ACMR EAST COAST OCEAN STRUCTURES
REVIEW OF SYSTEMS ANALYSIS PHASE

Report No. 76-10-1

TERA, Inc.

August 1976

FIG. 1. MAXIMUM PILE PENETRATION ESTIMATES
VULCAN 040 AND 060 HAMMERS

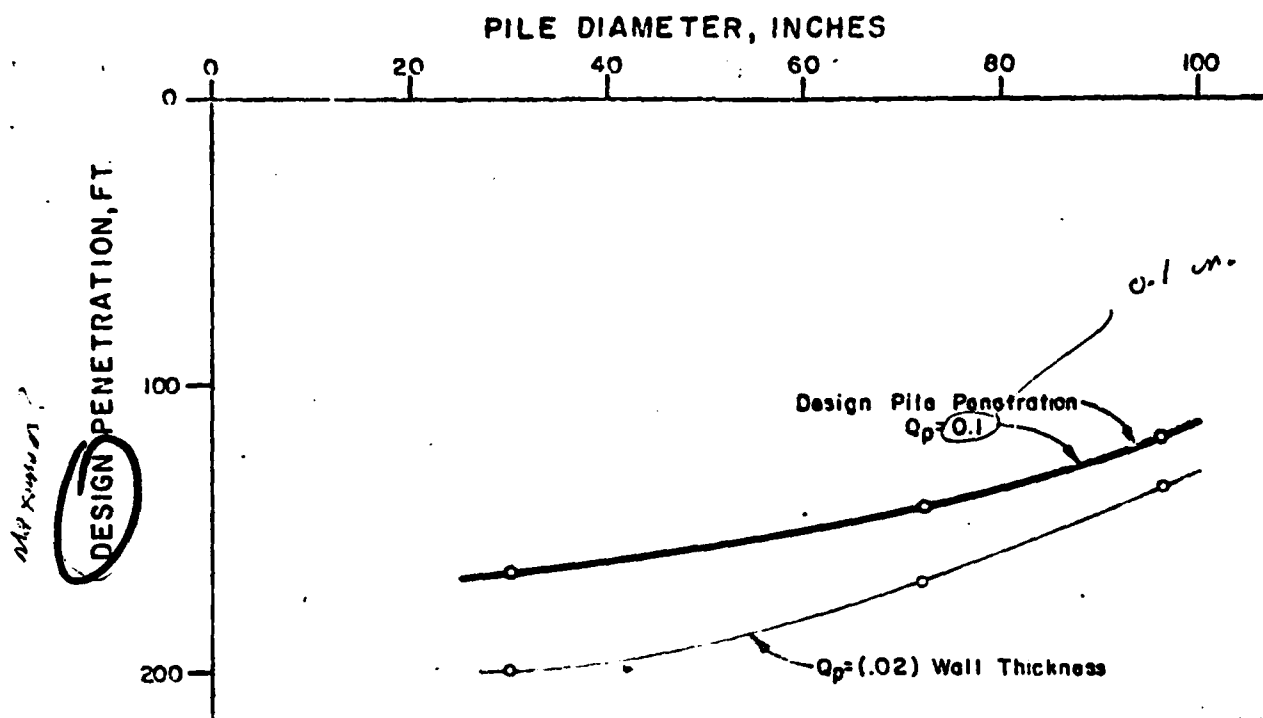
and a value of 0.1 ^{m.} for quake at the point was chosen in obtaining the values used for design penetrations. These values were plotted for Site 1 (81 ft MLW) as a function of pile diameter in order to estimate the maximum design penetration as a function of pile size (Fig. 1). Design axial capacity curves for tension and compression were then developed for several pile sizes, and plotted as a function of pile size (Fig. 2). The estimated axial capacities used in the curves were calculated from unit skin friction and end bearing values given in the foundation report. ⁴

FIG. 3. FOUR PILE CONCEPT, CONCEPTUAL DESIGN CRITERIA

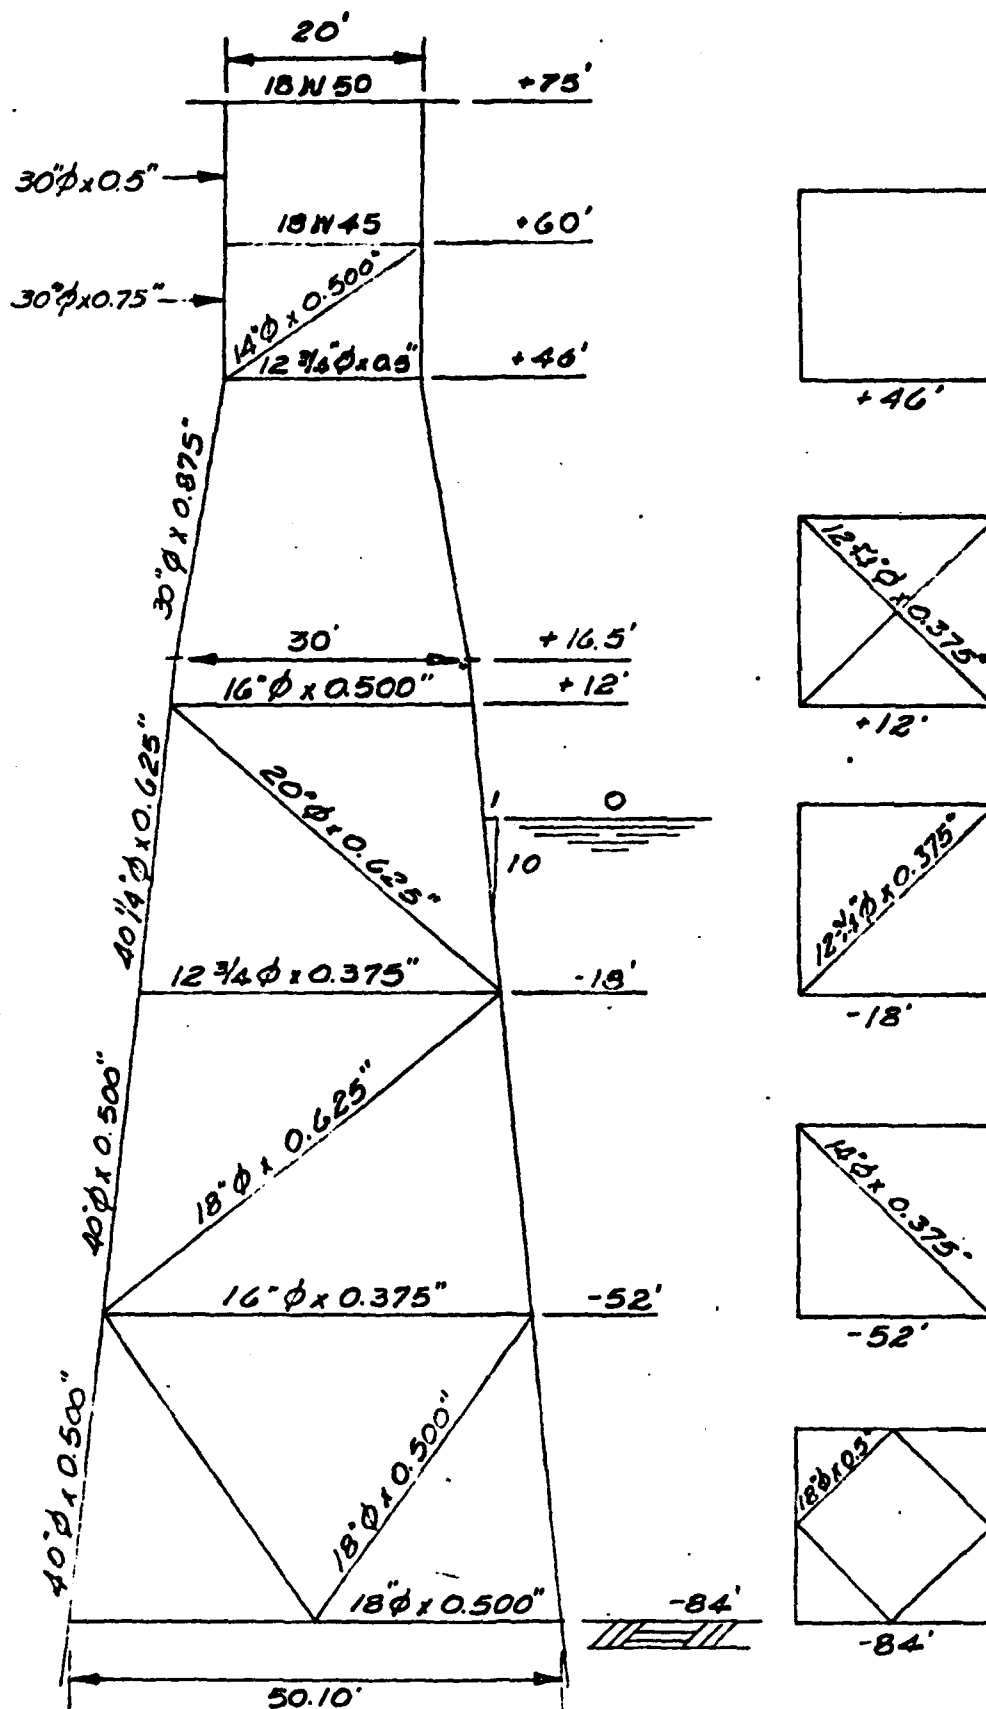
A comparison of Fig. 3 with the structural concept shown on page 12.07 of the A&E report⁷ indicates fairly close agreement in member sizes except for the superstructures which are substantially different in width and for the horizontal bracing which generally is controlled by the designer's choice of an allowable slenderness ratio rather than load carrying capacity. The jacket weight for the structure shown in Fig. 3 is about 276 kips which is 13% lower than the jacket weight reported by the A&E, mainly due to difference in horizontal bracing and possibly can sizes and corrosion allowances. The superstructure weight of 144 kips is considerably lower than the A&E's 172 kips (16%) due mainly to the different deck width. The A&E does not show a piling weight required for stresses only but it is noted that the piling shown is about 16% lighter than the 36 in. x 2 in. piling mentioned above which showed fairly good marginal drivability.
